Title		LIGO Laboratory	
ELIGO OMC QPD Whitening Board		*	
Size: B	DCC Number: D070263	Revision: A2	Engineer: R.S. Abbott
File: C:\Rich's Files\Mycadfiles\ISC\QPD\OMC_QPDTop.SchDoc		Date: 6/9/2008	Time: 4:18:20 PM
		Sheet 1 of 3

LIGO-D070263 Rev. A
 Four Channel QPD Whitening Board

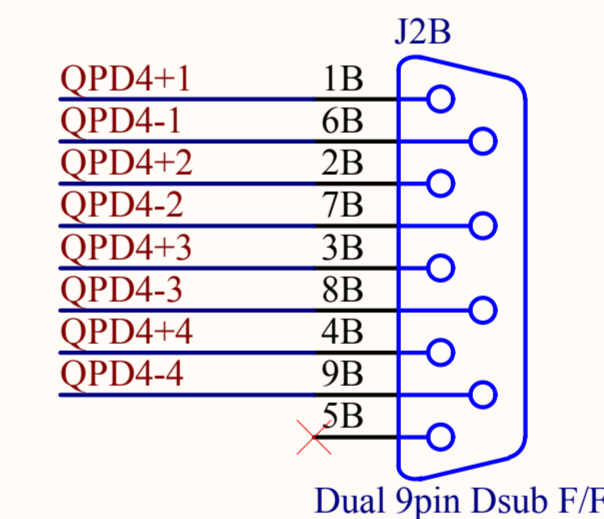
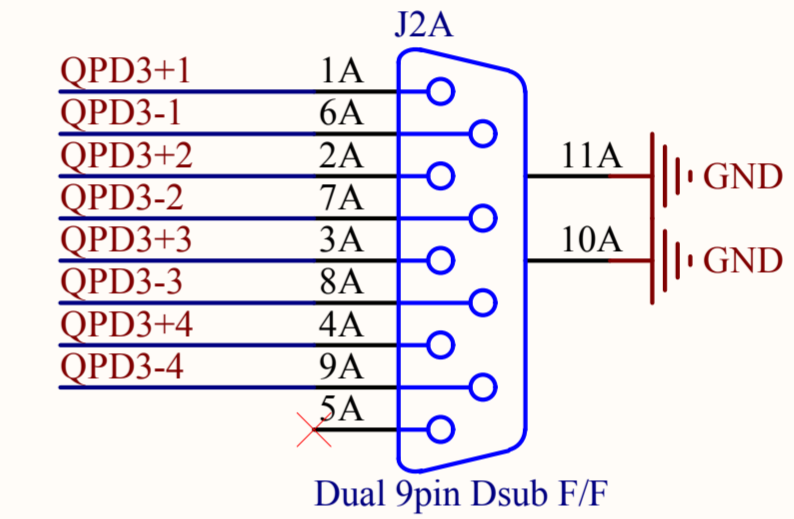
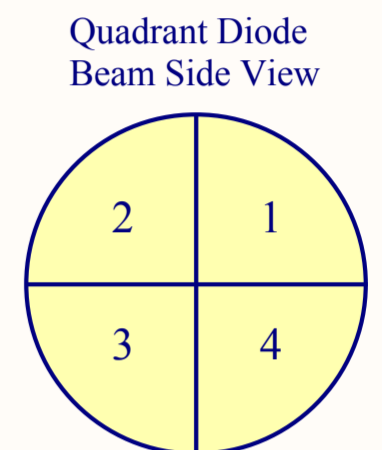
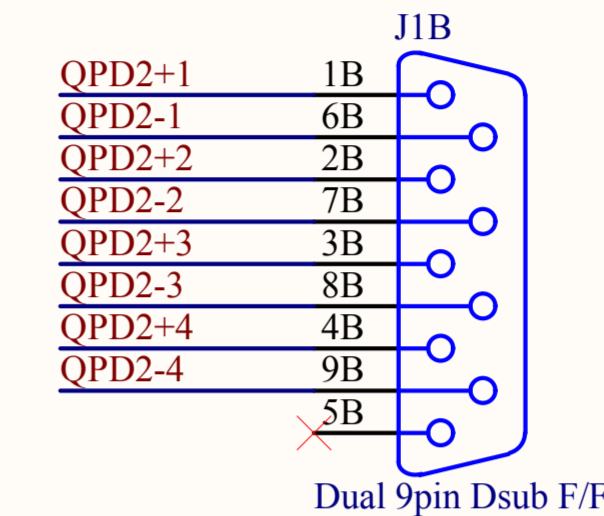
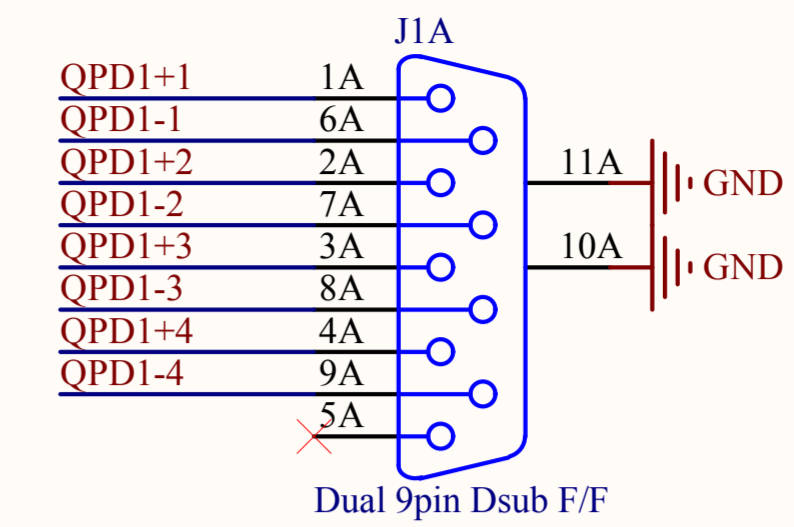
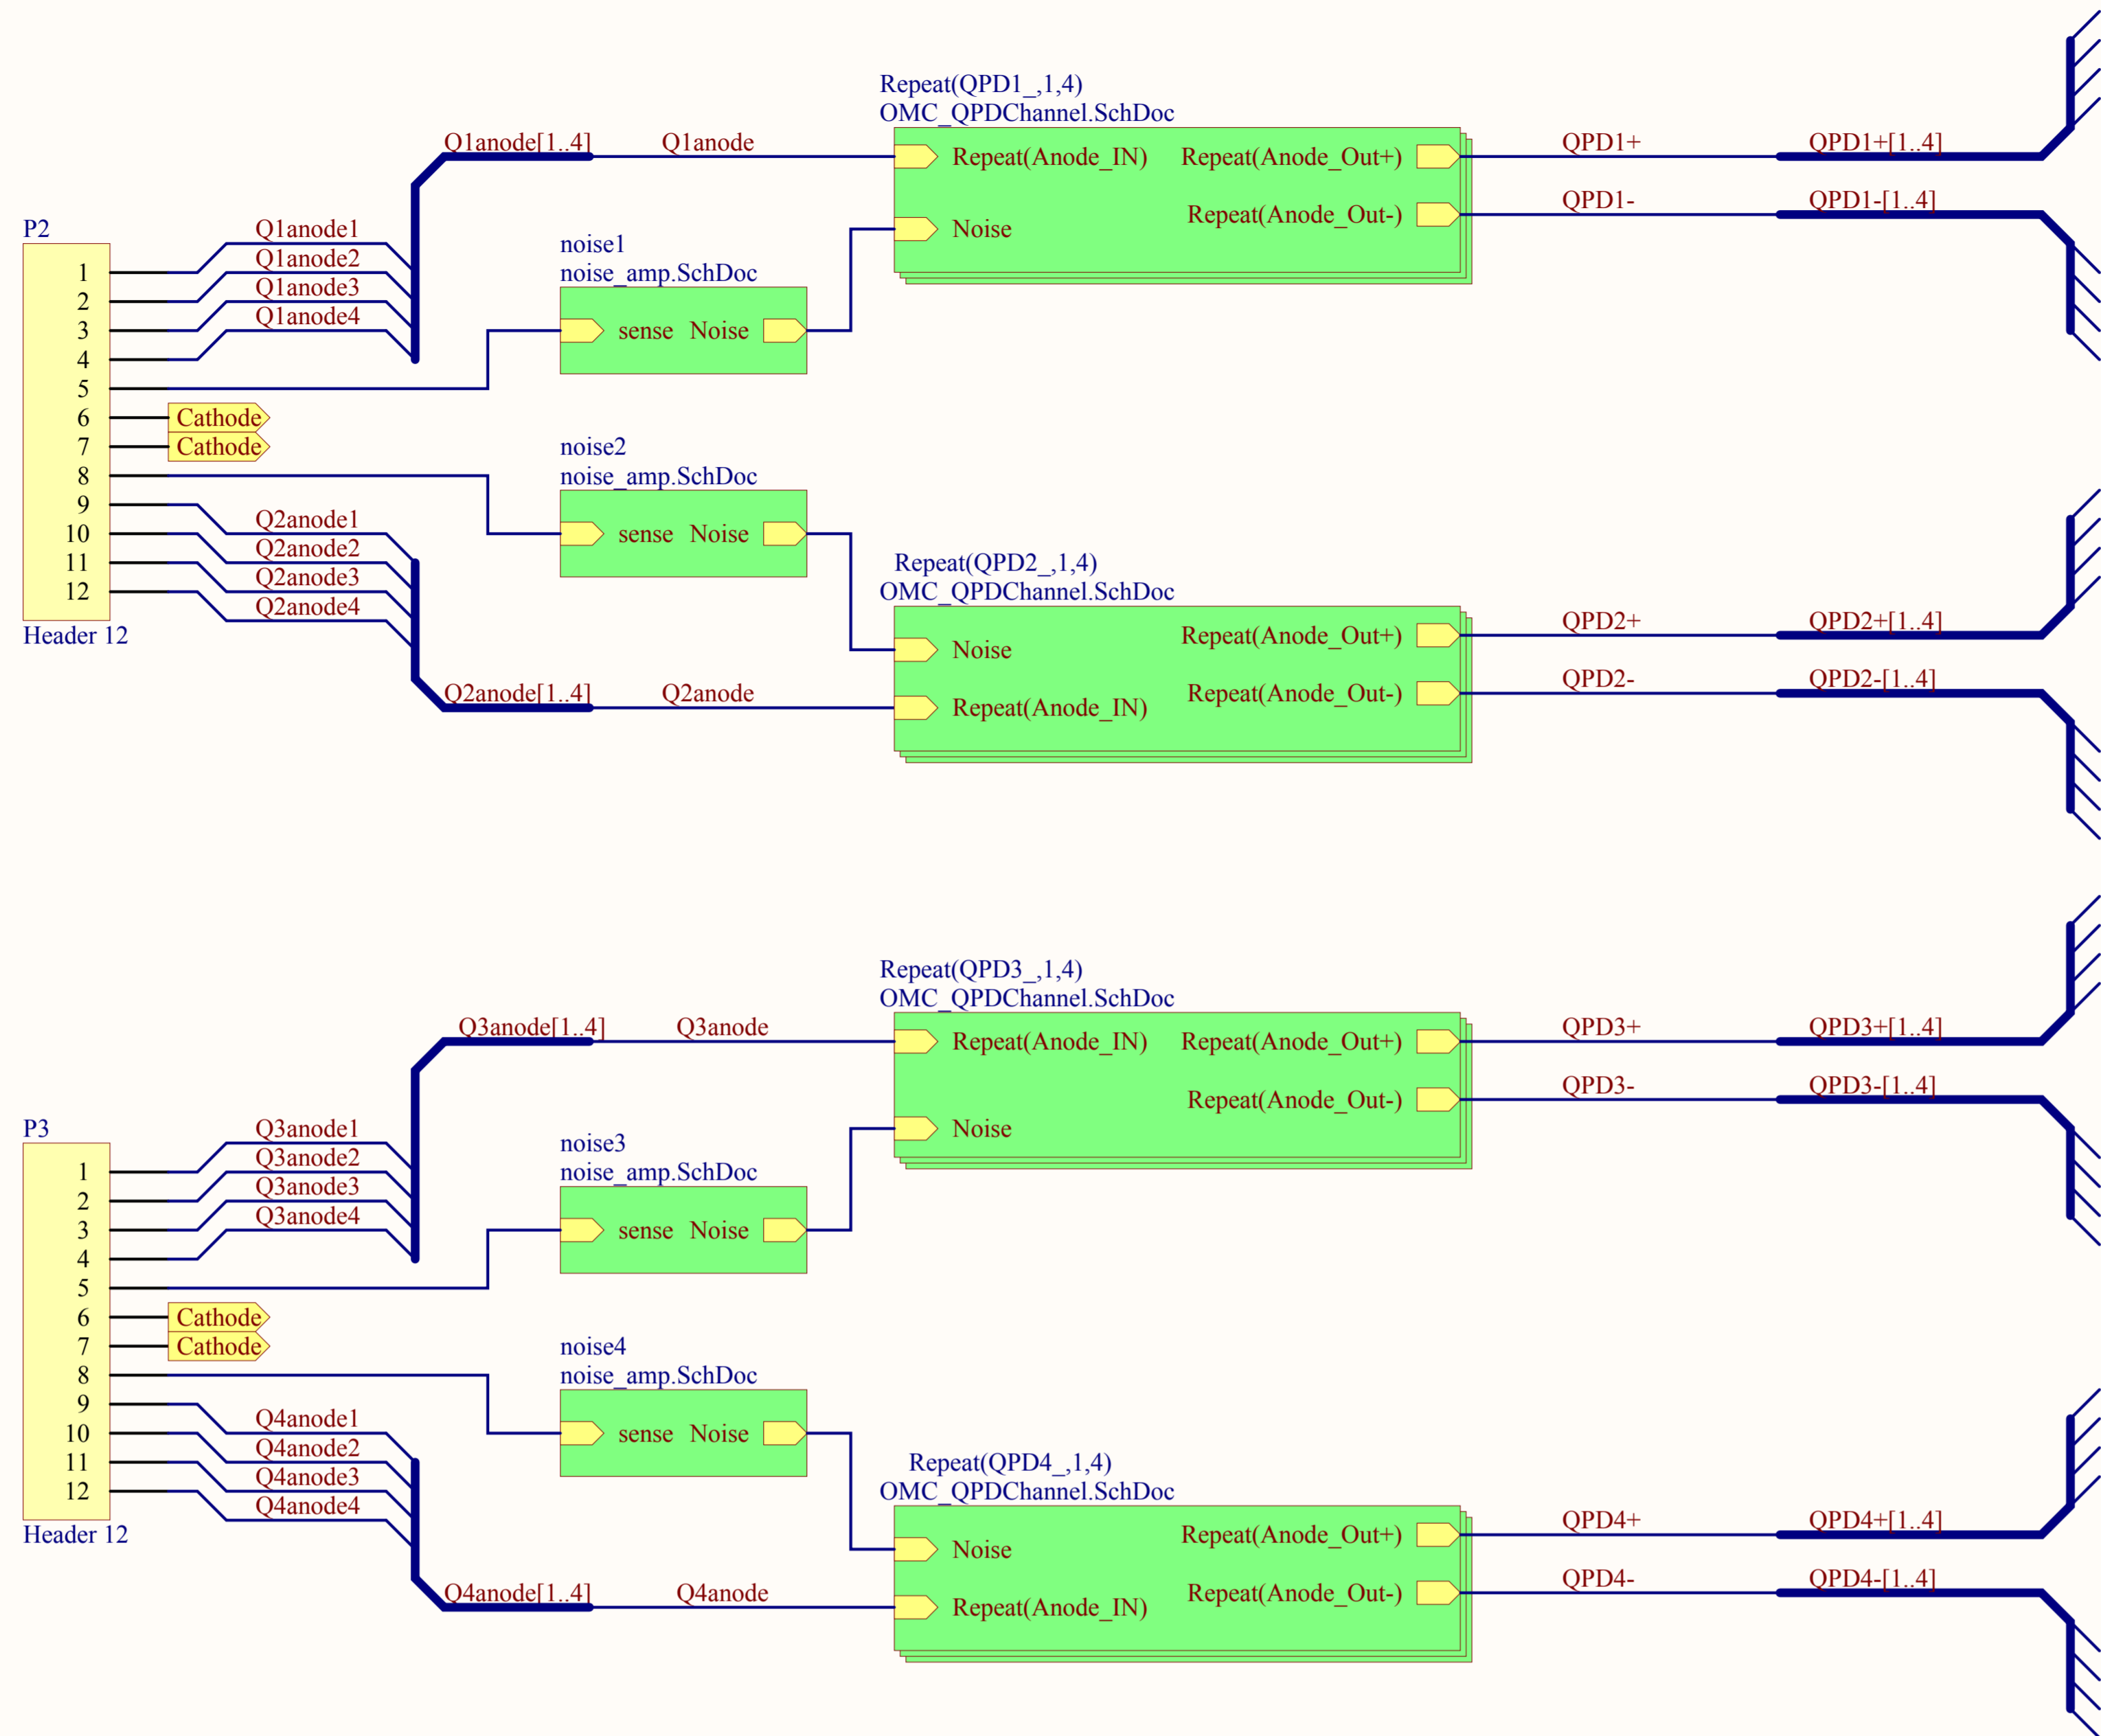
On P3:
A 14 pin header was installed with pin 14 tied to ground. Pin 13 was unused. This was done to allow the incoming cable shield to feed through the 25 pin Dsub and land on the circuit board ground. This must be changed on the next revision.

Also, the head used on the first version was a minimal walled header that is next to impossible to mate to. A standard header must be used in the future.

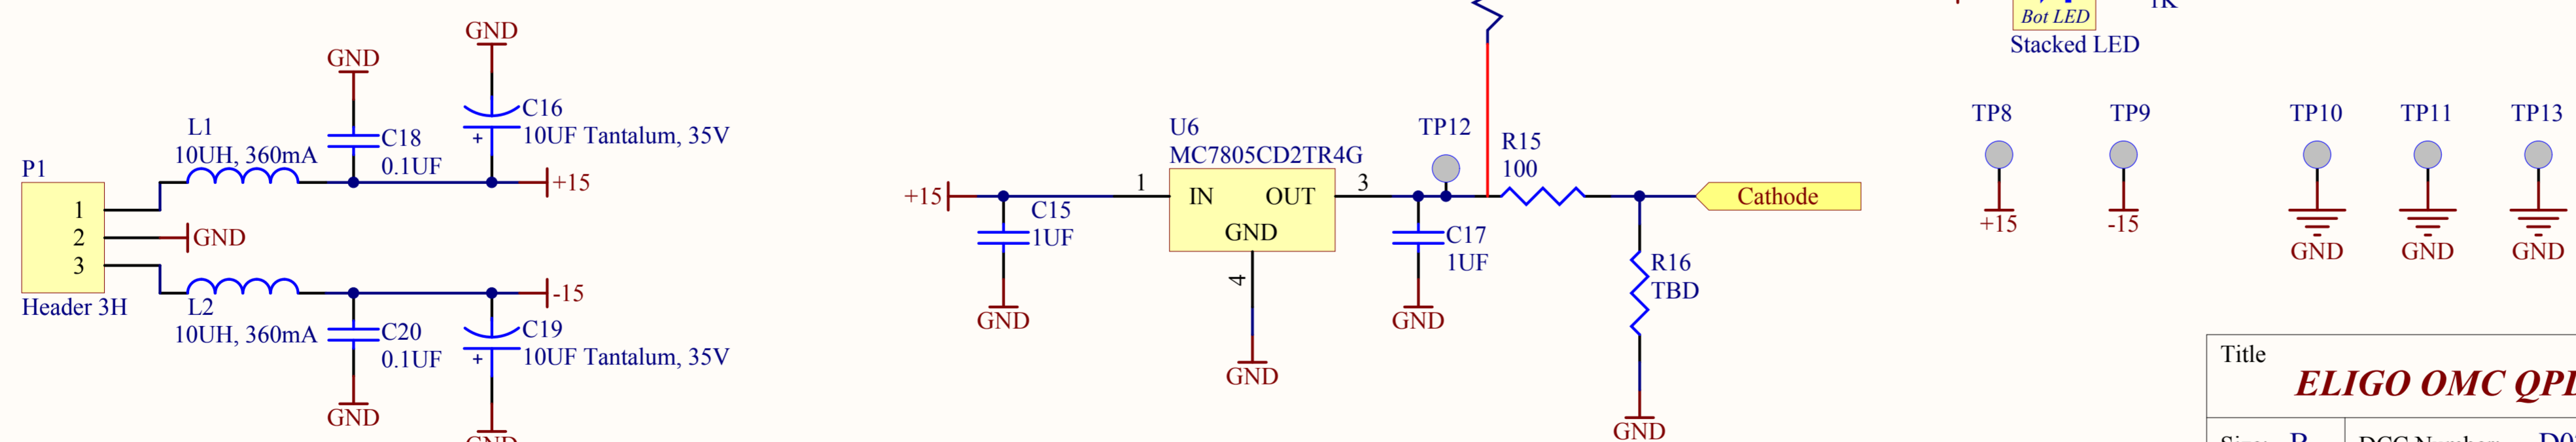
Revision History:
Rev. A: Initial release
Rev. A1: Changed U2, U3, U4 from OP-27 to OP184 to lower power dissipation
Changed U5 from AD826 to AD8672 to lower power dissipation
Changed C1 from 10pF to 33nF to cut overall bandwidth for noise reasons
Changed R19 from 100 to 4.99k due to miscalculation
Values of R6 and C10 changed due to part availability of C10
U7 changed from LT1128 to OP27 for current noise performance
C21 on noise amp is not needed.
Changed R15 from zero ohms to 100 ohms to back terminate the impedance of the cathode bias.
Rev. A2: Added a 470pF capacitor in parallel with R3, R4, and R5. This adds a pole to roll off the gain at high frequencies. The need for this was the discovery of a ground loop at LLO at ~500kHz.

Title		LIGO Laboratory		Date: 6/9/2008
ELIGO OMC QPD Whitening Board		*		
Size: B	DCC Number: D070263	Revision: A2	Engineer: R.S. Abbott	Time: 4:18:20 PM
File: C:\Rich's Files\MyCADfiles\ISC\QPD\OMC_QPDChannel.SchDoc				Sheet 2 of 3

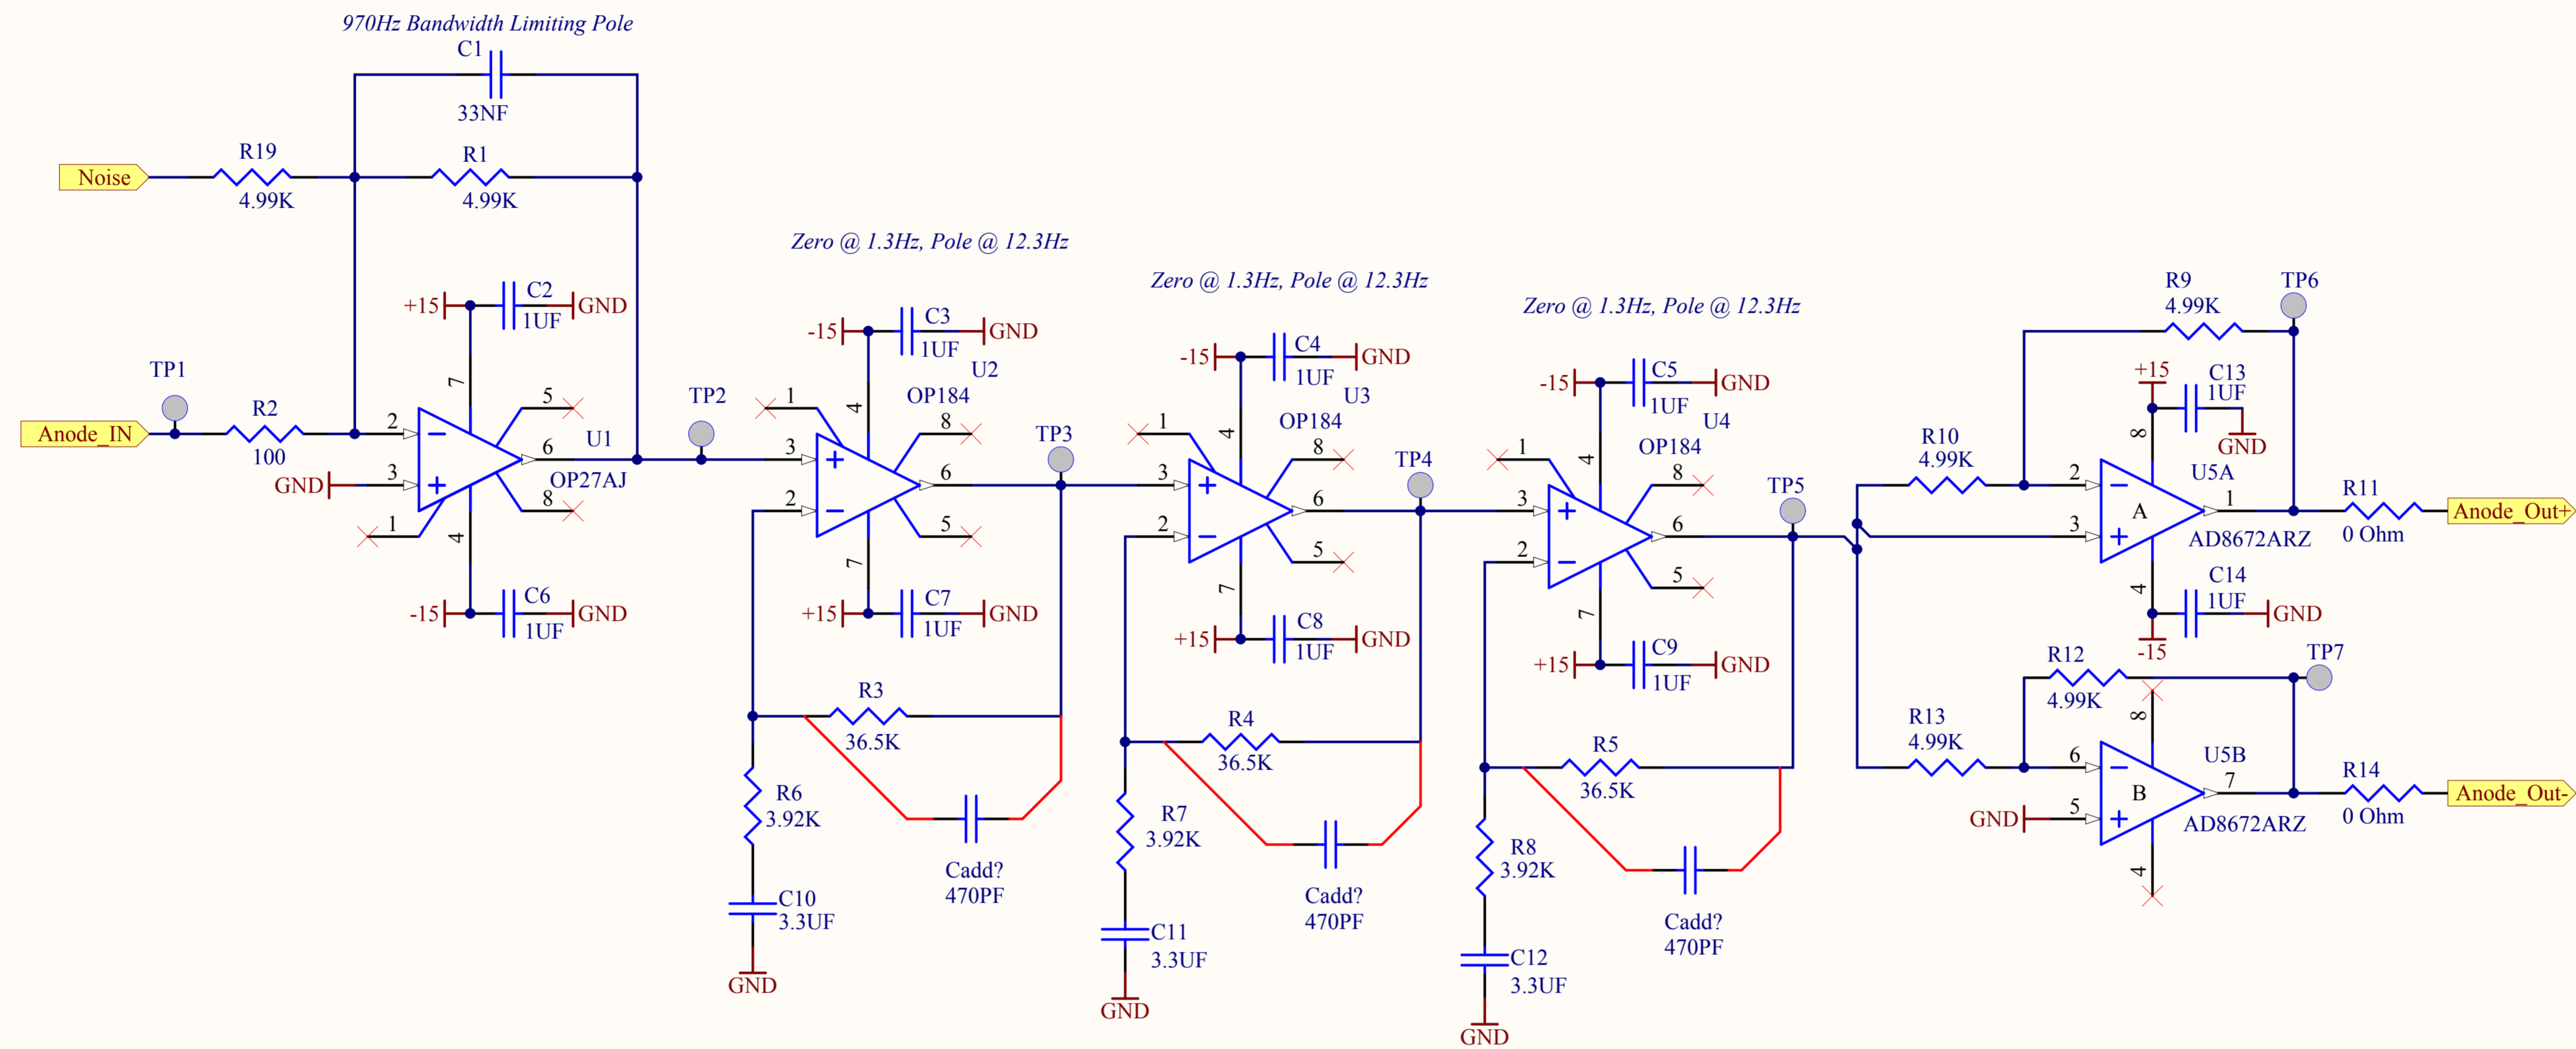
470PF Caps added to address a high frequency ground loop found at LLO
